TITLE: AIR CONDITIONING - FLOW CONTROL AND INDICATING - DELETE

TWO SENSORS PORTS ON 03 & VOC OZONE CONVERTER

6 DATE: Feb 15/10 SERVICE BULLETIN No.: A320-21-1190

# TITLE: AIR CONDITIONING - FLOW CONTROL AND INDICATING - DELETE TWO SENSORS PORTS ON 03 & VOC OZONE CONVERTER

Figure A-GBAAA - Sheet 01
Replacement of the Ozone Converters FIN 100HM and 101HM

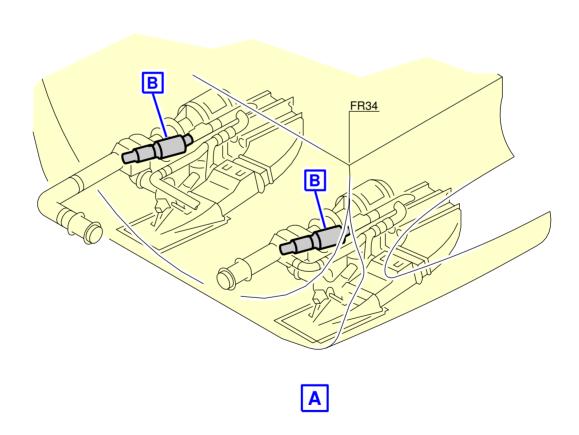
(1) Subtask 211190-960-201-001 - Replace the ozone converters 100HM and 101HM.

(a) Remove the ozone converters 100HM and 101HM.

Figure A-GBAAA - Sheet 02
Replacement of the Ozone Converters FIN 100HM and 101HM

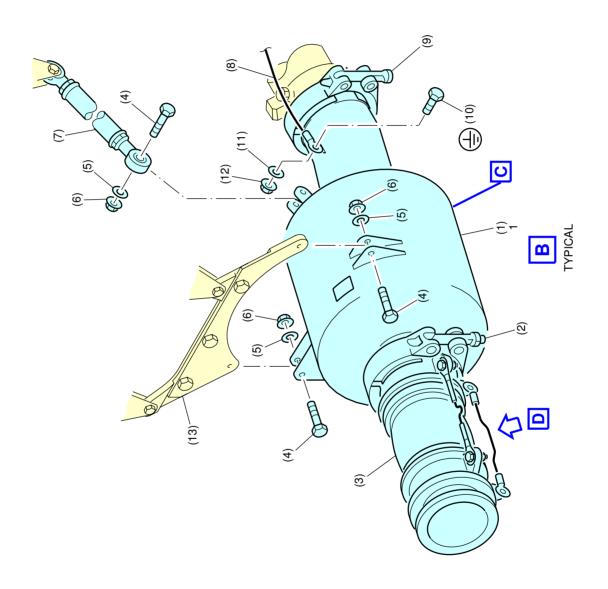
Remove from the bonding straps, Item (8), as shown in <u>Fig. A-GBAAA Sheet</u> <u>02</u>, Details B and C :

<u></u> ,	•		
2		Bolt		Item (10)	Retain	
2		Was	sher		Item (11)	Retain
2		Nut			Item (12)	Retain
		2	Remove from the Sheet 02, Details E		tem (1), as s	shown in Fig. A-GBAAA
2		Clar	mp		Item (2)	Retain
2		Clar	mp		Item (9)	Retain
		<u>3</u>	Remove from the r B and C:	rods, Item (7), as sho	wn in <u>Fig. A-C</u>	GBAAA Sheet 02, Details
2		Bolt Item (		Item (4)	Retain	
2		Was	sher		Item (5)	Retain
2		Nut	Nut		Item (6)	Retain
		<u>4</u>	Remove from the Sheet 02, Details E	_	tem (13), as	shown in Fig. A-GBAAA
2		Filte	er-Ozone	20499005	Item (1)	Discard
4		Bolt	Ī		Item (4)	Retain
4		Was	sher		Item (5)	Retain
4		Nut			Item (6)	Retain
	(b)	Inst	all the ozone conver	ters 100HM and 101H	HM.

<u>1</u> Put the ozone converters, Item 1, in position on the attachment fittings, Item (13), as shown in <u>Fig. A-GBAAA Sheet 02</u>, Details B and C:

2	Filte	er	20499006	Item 1	
		and install them with	h:		
4	Bolt			Item (4)	Retained at removal
4	Was	sher		Item (5)	Retained at removal
4	Nut			Item (6)	Retained at removal
	<u>2</u>		m (7), on the ozone of Details B and C, with		m 1, as shown in Fig. A-
2	Bolt			Item (4)	Retained at removal
2	Was	sher		Item (5)	Retained at removal
2	Nut			Item (6)	Retained at removal
	<u>3</u>	Examine the conve Sheet 03, Detail D.	erters and sleeves a	lignment as	shown in Fig. A-GBAAA
	<u>4</u>		the rods, Item (7), a		Fig. A-GBAAA Sheet 02,
	<u>5</u>	Install, as shown in	Fig. A-GBAAA Sheet	02, Details E	3 and C:
2	Clar	тр		Item (2)	Retained at removal
		and			
2	Clar	пр		Item (9)	Retained at removal
	<u>6</u>	Tighten the clamps m.daN (48.67 lbf.in.		(9), and tor	que the clamps to 0.55
	<u>7</u>	Connect the bonding Details B and C:	ng straps, Item (8), a	s shown in <u>F</u>	Fig. A-GBAAA Sheet 02,
2	Bolt			Item (10)	Retained at removal

Figure A-GBAAA - Sheet 03 Replacement of the Ozone Converters FIN 100HM and 101HM

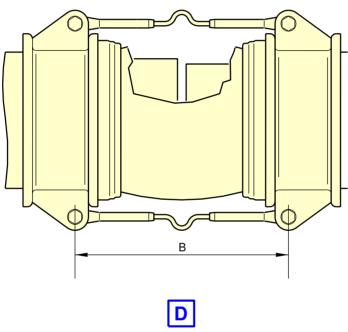
DIMENSIONS				
	mm	(in.)		
Α	476.0 TO 478.0	18.74 TO 18.82		
В	157.0 TO 164.0	6.18 TO 6.46

Figure A-GBBAA - Sheet 01
Replacement of the Ozone Converters FIN 100HM and 101HM

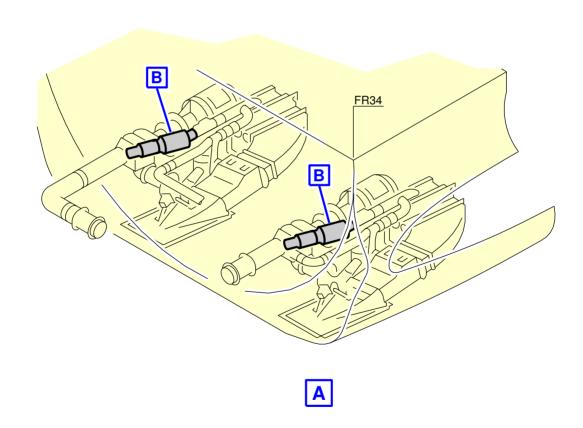
(1) Subtask 211190-960-201-002 - Replace the ozone converters 100HM and 101HM.

(a) Remove the ozone converters 100HM and 101HM.

Figure A-GBBAA - Sheet 02
Replacement of the Ozone Converters FIN 100HM and 101HM

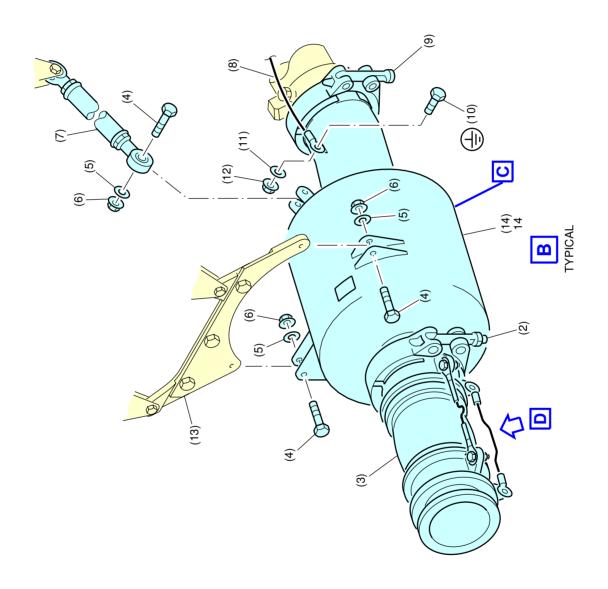
$\underline{1}$  Remove from the bonding straps, Item (8), as shown in  $\underline{\text{Fig. A-GBBAA Sheet}}$   $\underline{02}$ , Details B and C :

<u>2</u>	Remove from the Sheet 02, Details E		tem (14), as	shown in <u>Fig. A-GBBAA</u>
2		Cla	mp		Item (2)	Retain
2		Cla	mp		Item (9)	Retain
		<u>3</u>	Remove from the B and C:	rods, Item (7), as sho	own in <u>Fig. A-</u>	GBBAA Sheet 02, Details
2		Bolt	t		Item (4)	Retain
2		Wa	sher		Item (5)	Retain
2		Nut			Item (6)	Retain
		<u>4</u>	Remove from the Sheet 02, Details E	_	Item (13), as	shown in Fig. A-GBBAA
2		Filte	er-Ozone	44018004	Item (14)	Discard
4		Bolt	t		Item (4)	Retain
4		Wa	sher		Item (5)	Retain
4		Nut			Item (6)	Retain

(b)	Inst	all the ozone conver	ters 100HM and 101	НМ.	
		Ref	er to (Refer to AMM	21-51-41, Page Bloc	k 401)	
		<u>1</u>		verters, Item 14, in p Fig. A-GBBAA Sheet		e attachment fittings, Item and C:
2		Filte	er	44018005	Item 14	
			and install them wi	ith:		
4		Bolt	t		Item (4)	Retained at removal
4		Wa	sher		Item (5)	Retained at removal
4		Nut			Item (6)	Retained at removal
		<u>2</u>		em (7), on the ozone 2, Details B and C, w		tem 14, as shown in Fig.
2		Bolt	t		Item (4)	Retained at removal

Figure A-GBBAA - Sheet 03
Replacement of the Ozone Converters FIN 100HM and 101HM

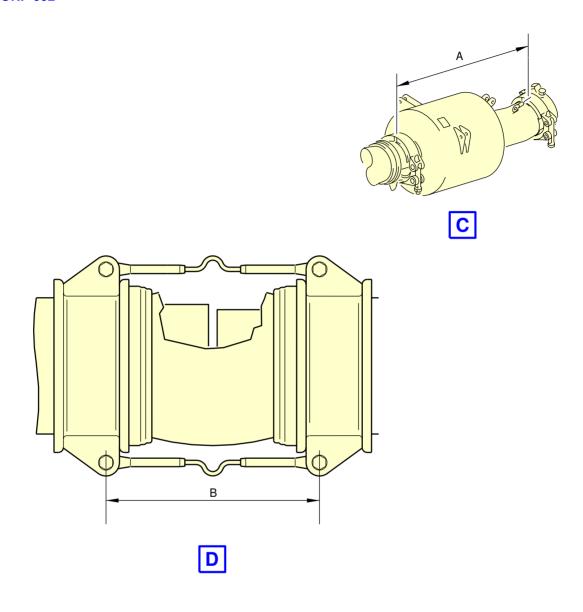
2	Was	her	Item (5)	Retained at removal
	2	Nut		Item (6)	Retained at removal
		<u>3</u>	Examine the converters and sleeves al Sheet 03, Detail D.	ignment as s	shown in Fig. A-GBBAA
		<u>4</u>	If necessary adjust the rods, Item (7), a Details B and C, and in Fig. A-GBBAA S		
		<u>5</u>	Install, as shown in Fig. A-GBBAA Sheet	02, Details B	and C:
	2	Clan	np	Item (2)	Retained at removal
			and		
	2	Clan	np	Item (9)	Retained at removal
		<u>6</u>	Tighten the clamps, Item (2) and Item m.daN (48.67 lbf.in.).	(9), and toro	que the clamps to 0.55
		<u>7</u>	Connect the bonding straps, Item (8) a Details B and C:	s shown in <u>F</u>	ig. A-GBBAA Sheet 02,
	2	Bolt		Item (10)	Retained at removal
	2	Was	her	Item (11)	Retained at removal
	2	Nut		Item (12)	Retained at removal
VI.	ΕΛΙΙ

DIMENSIONS				
	mm	(in.)			
Α	476.0 TO 478.0	18.74 TO 18.82			
В	157.0 TO 164.0	6.18 TO 6.46
